Design Review Commission Report

Meeting Date: Thursday, January 7, 2016
(continued from Thursday, December 3, 2015)

Subject: **705 North Camden Drive (PL1500923)**
A request for an R-1 Design Review Permit to allow the construction of a façade remodel to an existing two-story single-family residence located in the Central Area of the City north of Santa Monica Boulevard. The Commission will also consider adoption of a Categorical Exemption, pursuant to the California Environmental Quality Act.

Applicant's Written Response to Commission's Comments

PROPOSED ELEVATION

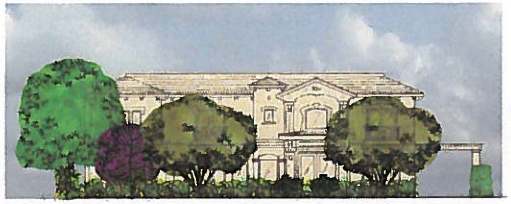
1.The front entry is too bold and bulky for the project and the 1st floor roof intersecting the two story entry does not work.

2.The tower makes the entry too congested.

3. the parapet wall showing above the roof is not necessary.

5. Upper windows above the bay are inconsistent with the style.

6. Sliding doors are not allowed in the front.

7. Balconies are too wide.

10. Mass scale and overdesign to be revised and refined.

Response: The entry has been refined and articulated as one story using distinguished color and material, roof Overhang minimized and corbels eliminated on the first floor.

Response: The tower roof is eliminated and continuous roof is introduced over the design element next to the entry which is broken to upper and lower parts in order to clear more space around it and look less bulky.

Response: The parapet wall is terminated at the top of the roof now so no that wall is visible from the street.

Response: Those windows are removed in the revised design.

Response: The sliding doors have been replaced by French doors swinging in .

Response: The balconies are narrowed down to 6'-6" in width , and the guardrail is
6'-2" wide.

<u>Response:</u> The tower is taken out. Window above the entry narrower with simpler surrounds and more space around it. Ornamental features of rake and highlight color at the 2nd floor above the entry are eliminated . Entry surrounds and highlight are reserved for the one Story entry. The window on the left side of the entry is reduced in width so now the focus is on the entry itself.

LIGHTING PLAN

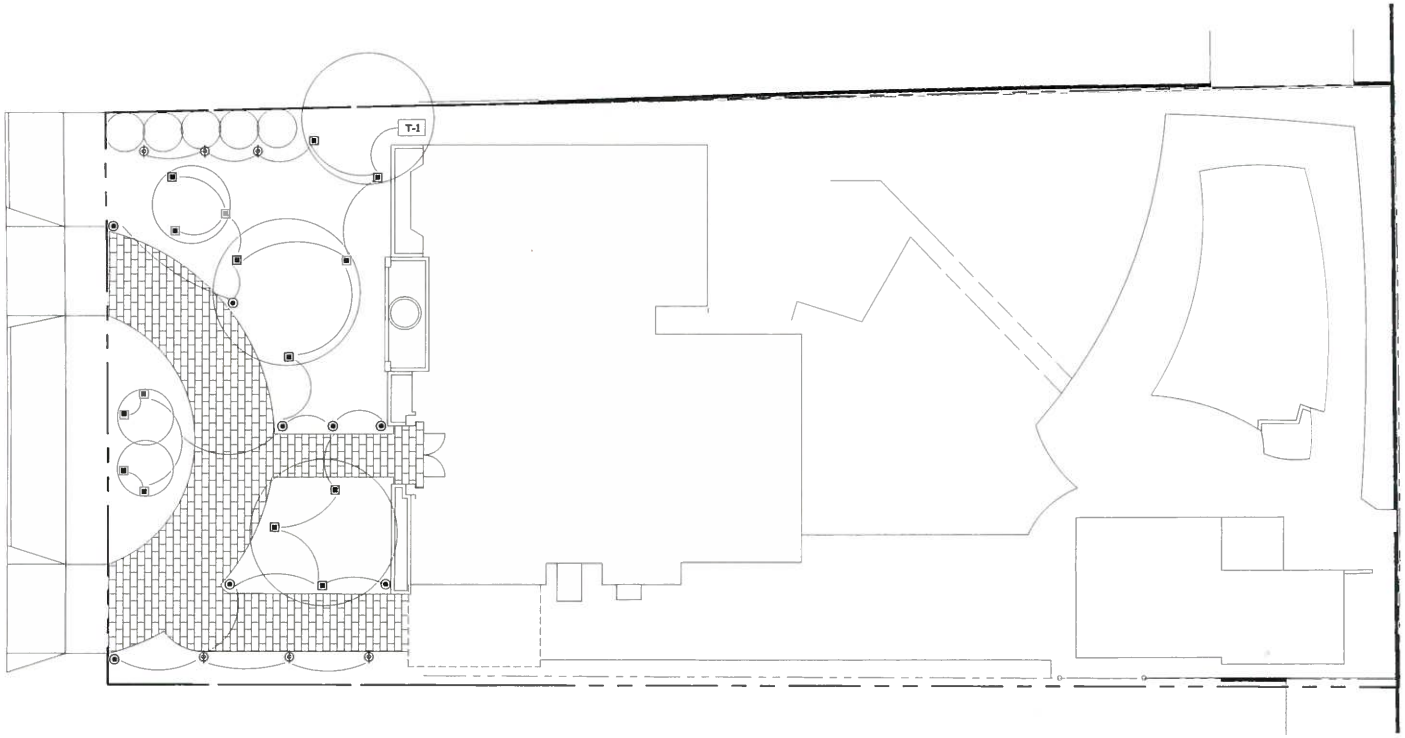
8. number of landscaping light fixtures unclear .

<u>Response:</u> The number of landscaping light fixtures is now 24 as tabulated on L-3.

FRONT ELEVATION
1/4" = 1'-0"

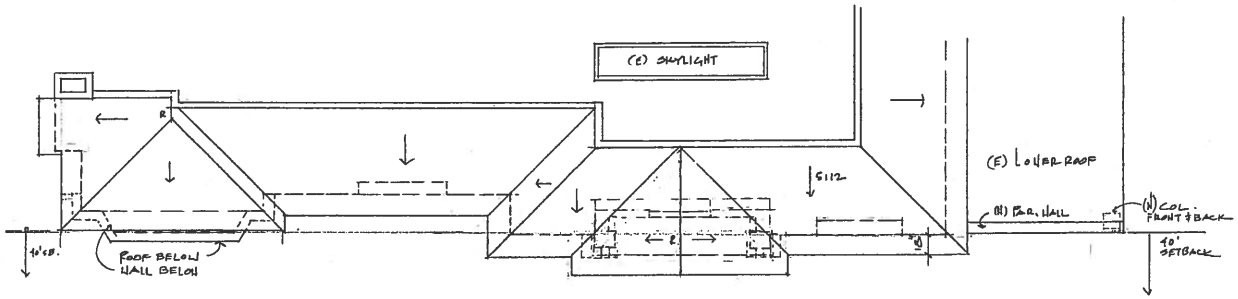
9. Porte de cacher roof is too thin and its support columns too bulky.

<u>Response:</u> The existing roof appears to be thicker in the new design as a new parapet wall on the front and side are added . The columns are reduced to 1'-0"x1'-0".
